Information Use
Control of Licensing Document Changes

Attachment 1 - DSAR/IFHA/LTP Change Form

Change No.: EC 70840	Unit(s): FCS
Type of change: <input checked="" type="checkbox"/> Technical <input checked="" type="checkbox"/> Editorial	
Affected DSAR/IFHA/LTP Section(s), Table(s), Figure(s), Page(s):	
DSAR-1.2, Summary Plant Description; DSAR-1.11 Specific References:	
DSAR-2.2, General Description of Site and Environs; DSAR-2.7, Hydrology;	
DSAR-2.8, Demography; DSAR-2.11, Section 2 Specific References; DSAR figure 1.2-1;	
DSAR figure 1.2-3; DSAR figure 2.2-4; DSAR figure 12.1-1.	
Description of Change (Provide summary here and attach affected pages marked to show the changes):	
<p>This DCR EC will revise sections and figures of the DSAR that are no longer relevant to the facility and will update chapters and sections that continue to be relevant as per R.G. 1.184 guidance. The existing site Design and Licensing Basis is unchanged by this EC. In addition to other administrative changes this DCR is corrective action for CR-2021-00073.</p> <p>DSAR Sections 1.2, 2.2, 2.11 and DSAR figure 2.2-4 (file 36045) will be revised to address Exclusion Area Boundary (EAB) wording and to rem

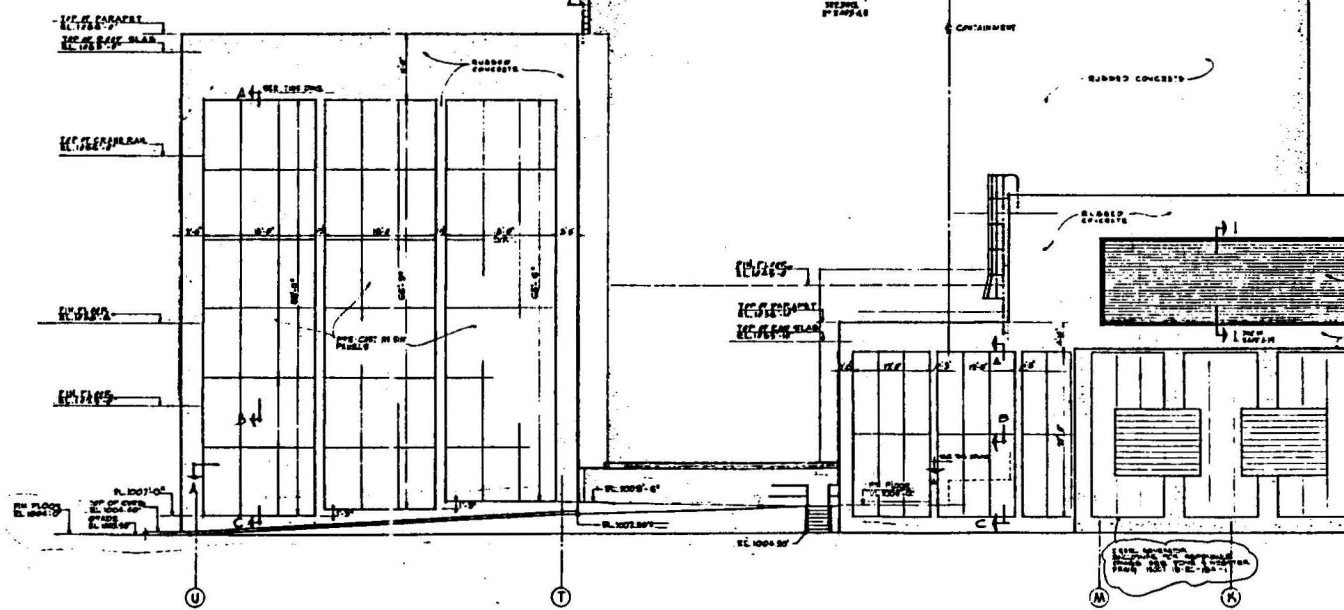
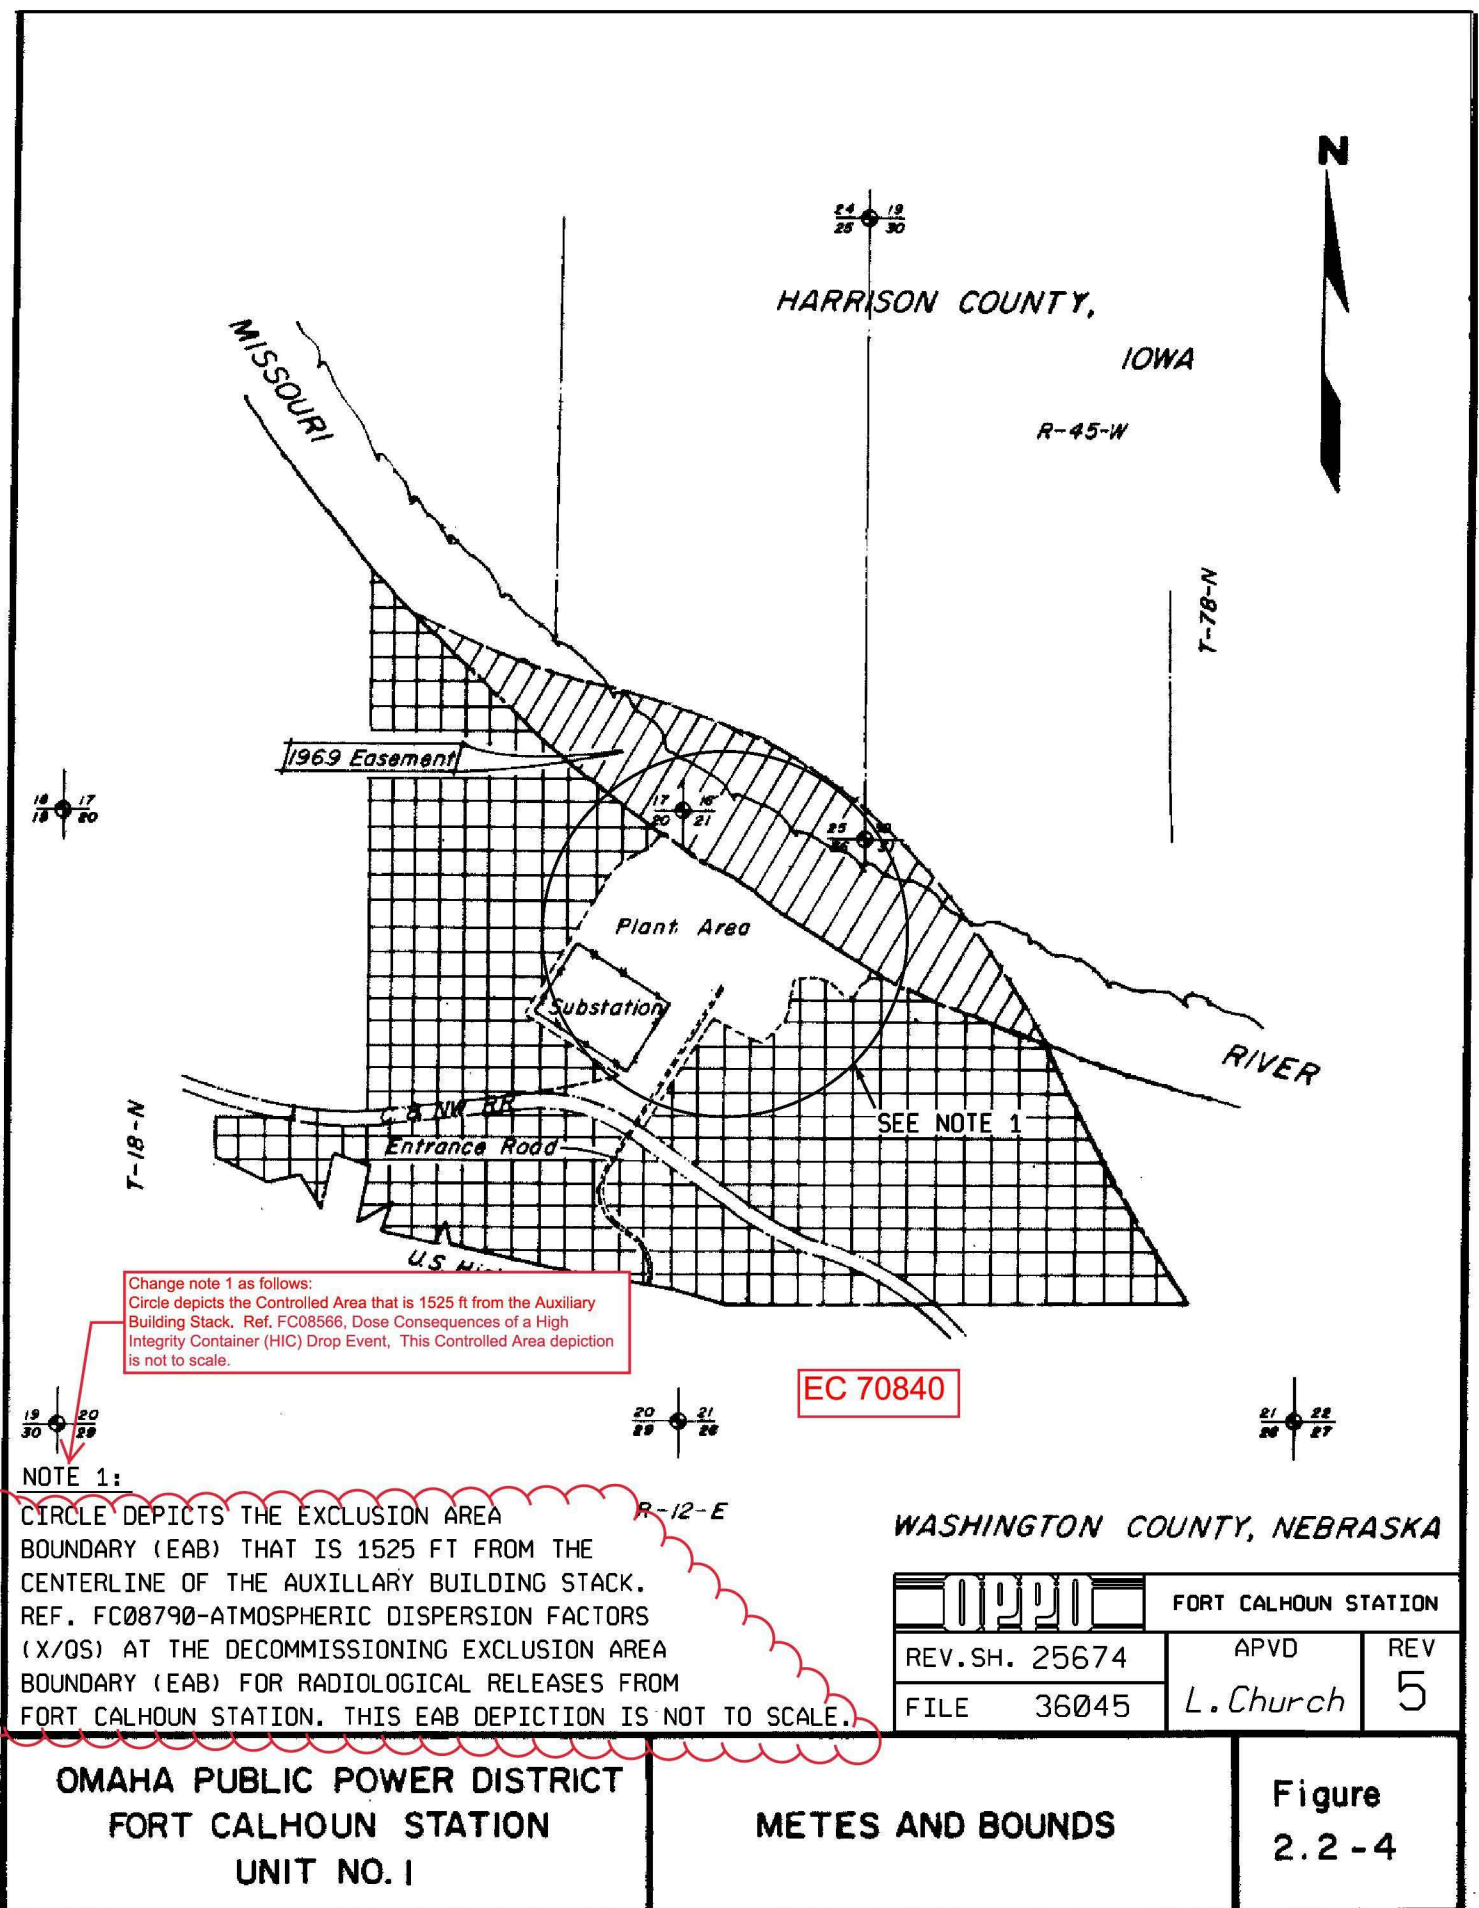
Drawing to be
stated as
historical and
removed as a
DSAR 1.2 figure.

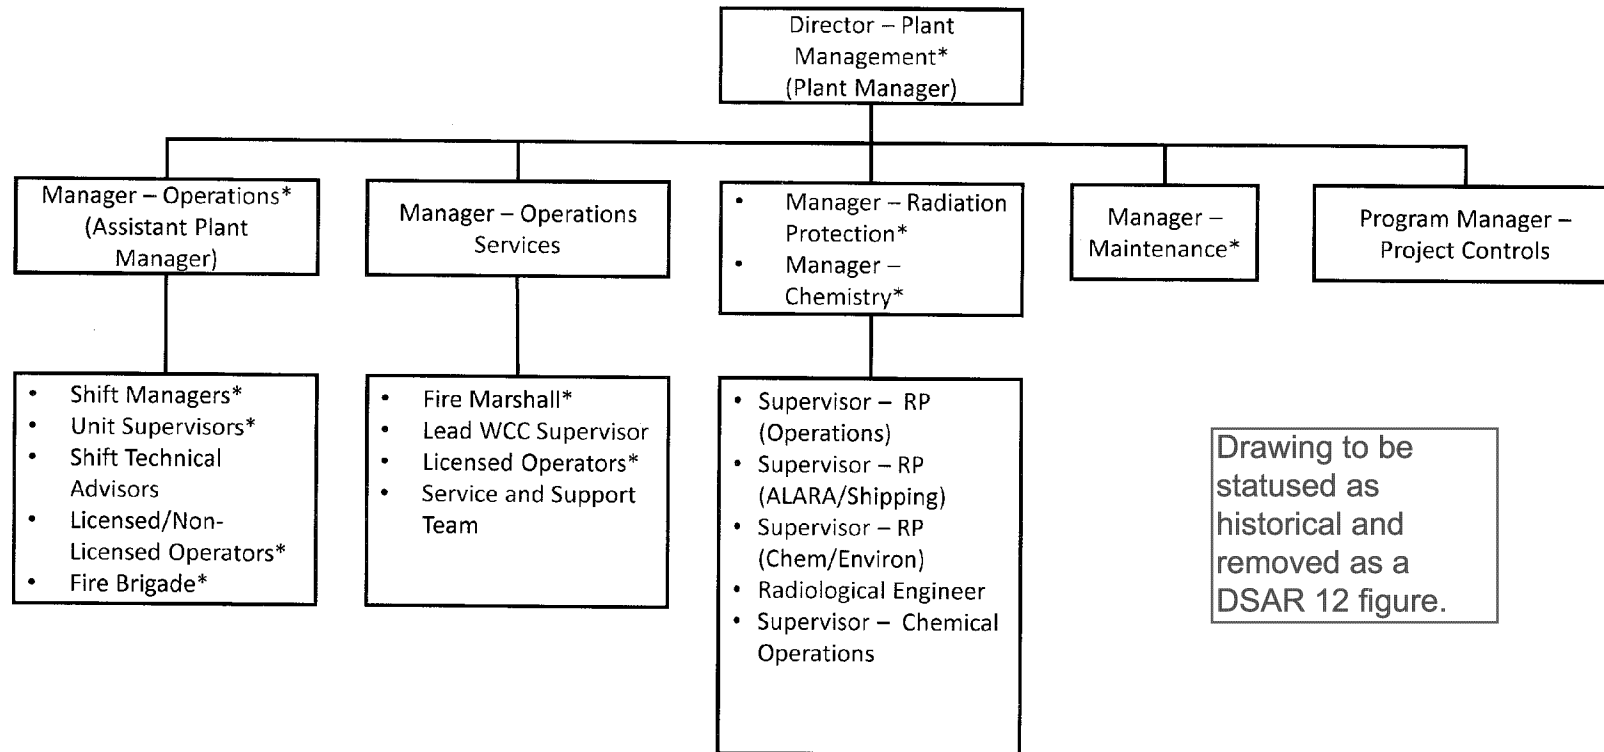
Drawing to be
statused as
historical and
removed as a
DSAR 12 figure.
